Re: Redevelopment of Alexandra Basin and Berths 52 and 53
together with associated works in Dublin Port,
Alexandra Road, Dublin 1.

An Bord Pleanála Ref: PA 0034

Proposed Alexandra Basin Redevelopment

Reply to Request for Further Information

Fig. 2.2

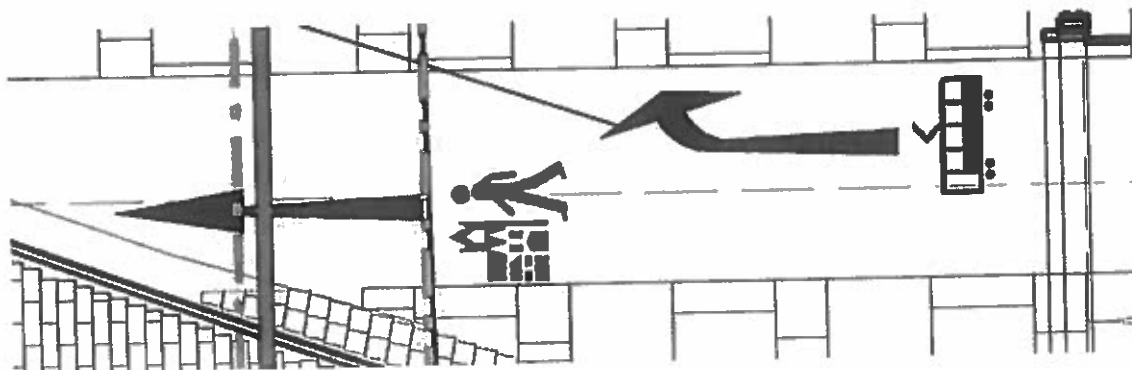
As the Luas Terminus is located outside the line of vision of those passengers exiting at the quayside, signage will be provided to direct passengers to the Luas (as well as to the City Centre). This can be located within DPC's lands. Rather than add to the existing signs and increase visual clutter, directional signage will be provided in the ground surface, not unlike the signage at the 'Pig Trap' on Sir John Rogerson's Quay. It is illustrated in MOLA Drg. No. 130111-02-2100 Rev A1 and highlighted in Fig. 2.2 below.
